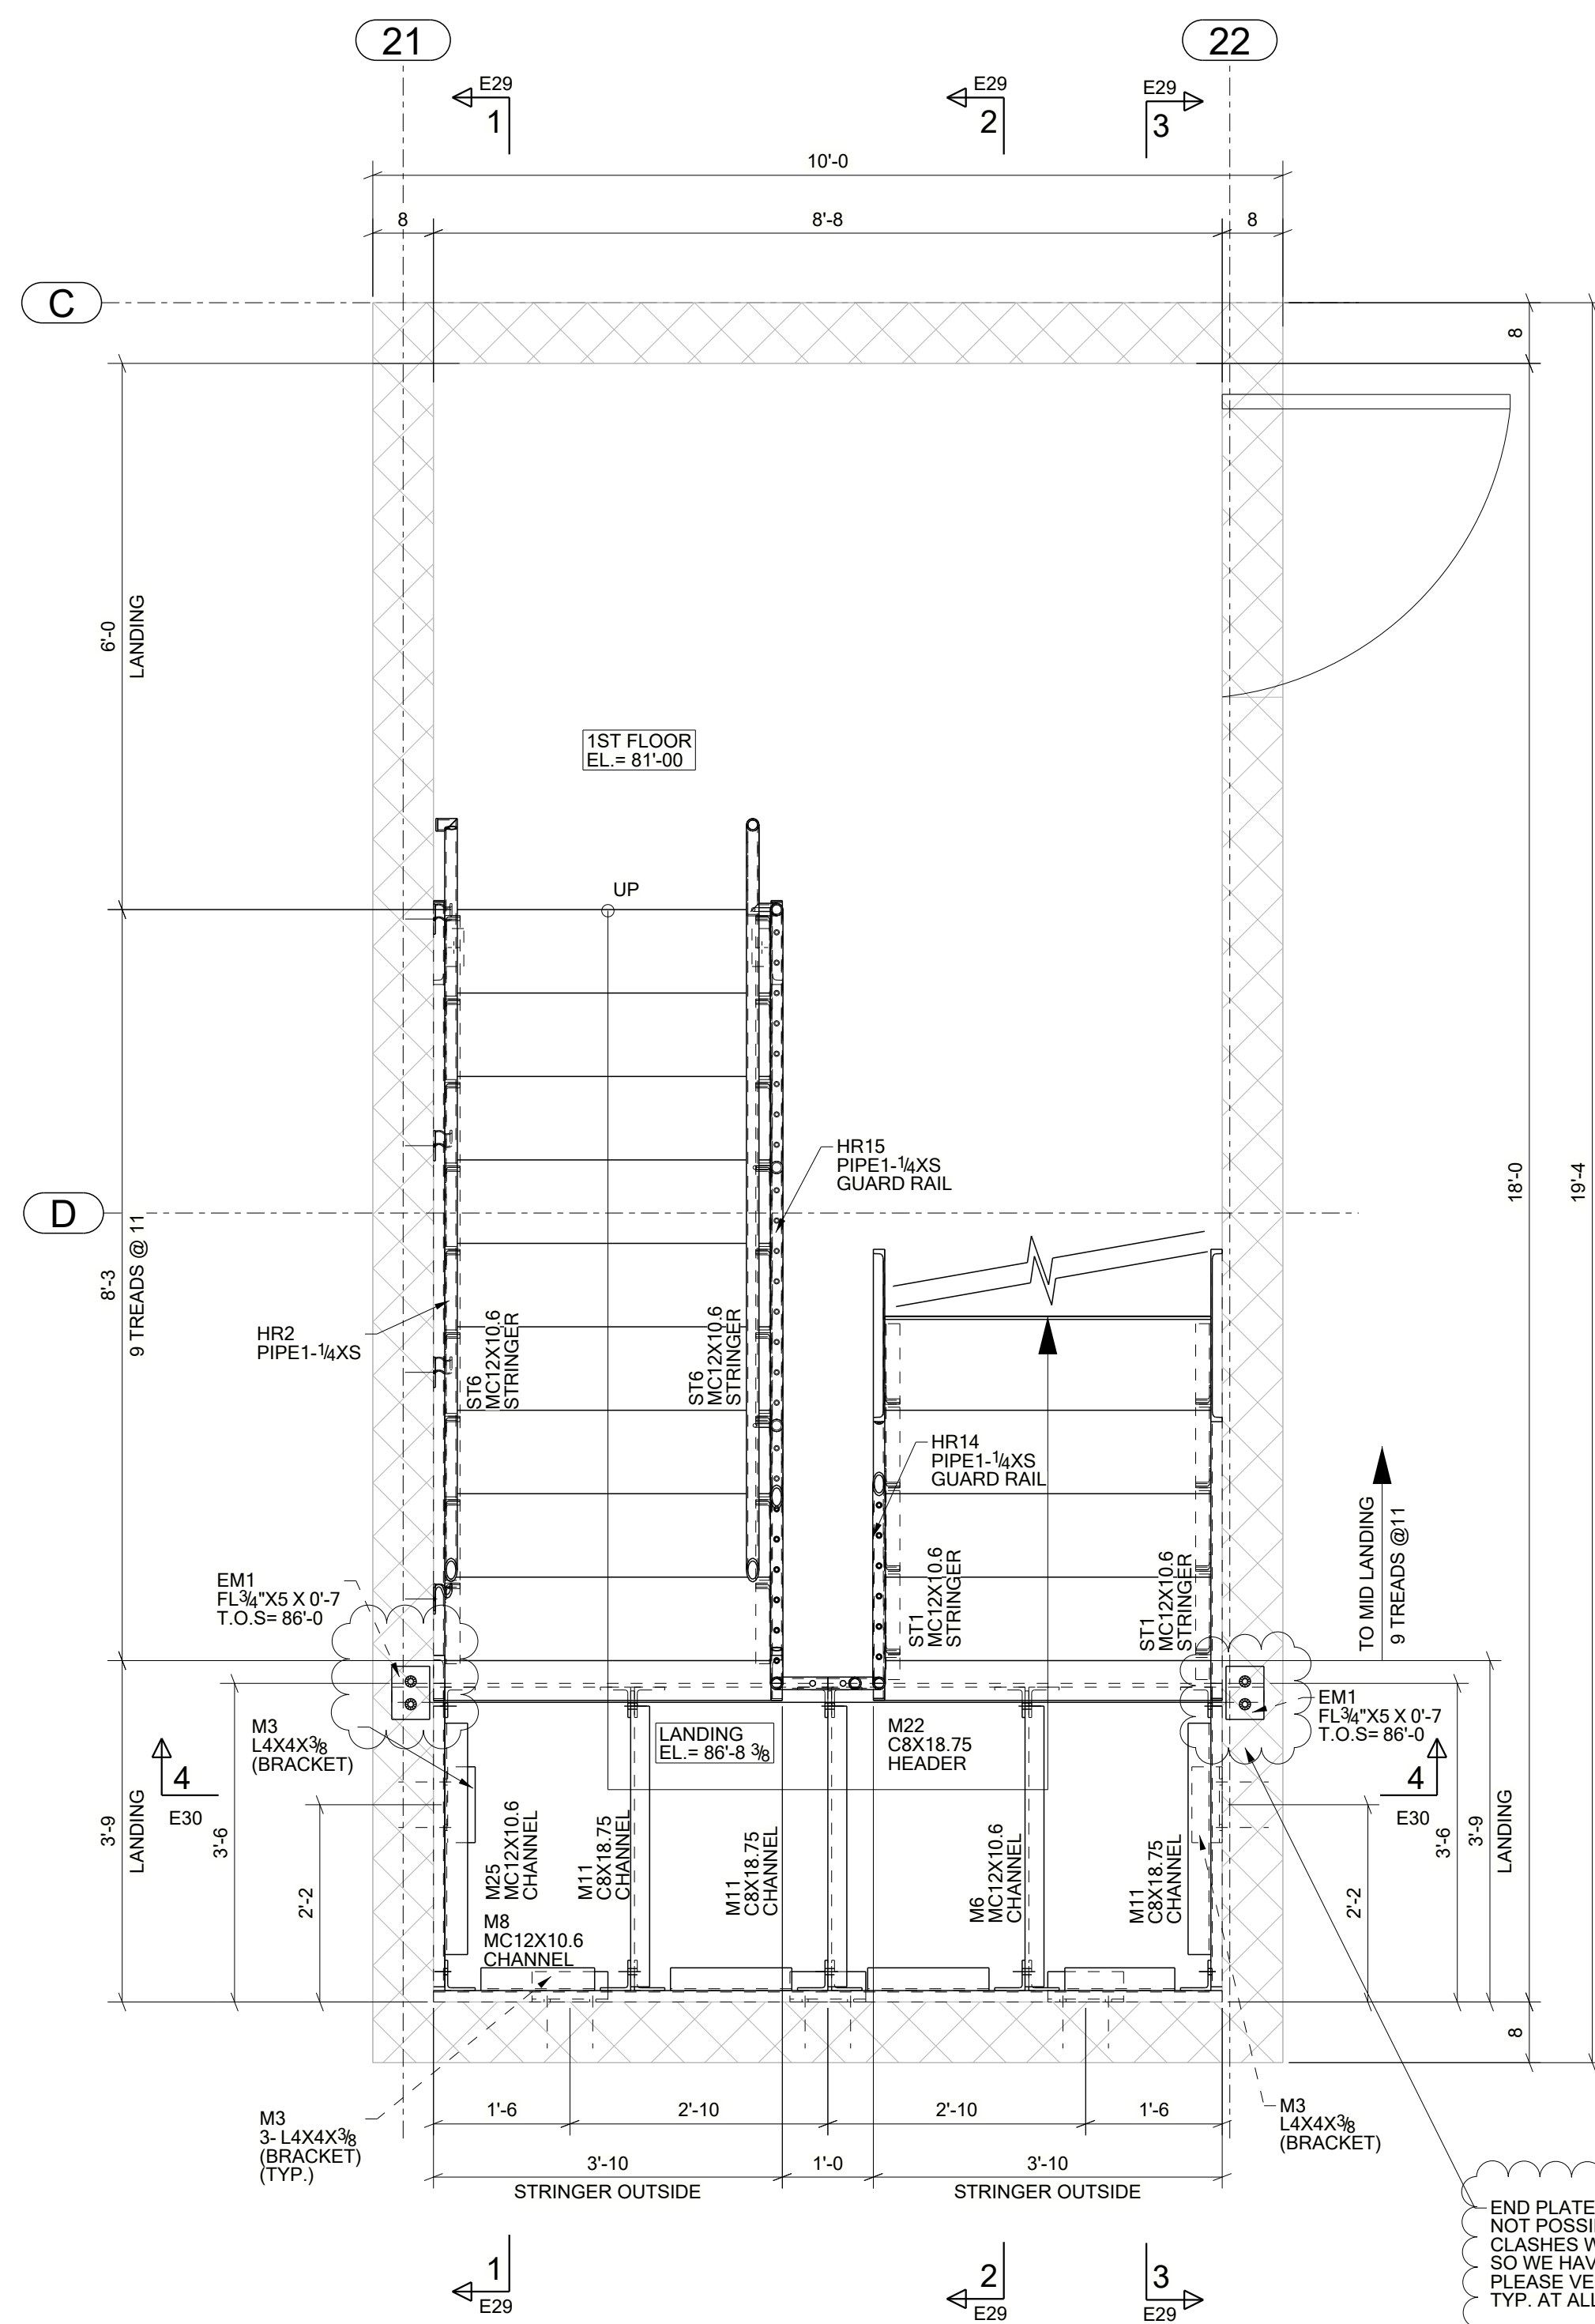
END PLATE CONNECTION IS NOT POSSIBLE BECAUSE ANCHOR ROD CLASHES WITH STRINGER SO WE HAVE KEEP POCKET CONNECTION ONLY PLEASE VERIFY BEFORE FABRICATION. TYP. AT ALL LOCATIONS.

G.C PLEASE VERIFY
1. ALL STAIR DIMENSIONS
2. ALL RAILING PROFILES
BEFORE FABRICATION

REFER 'E34' FOR CONNECTION DETAILS.
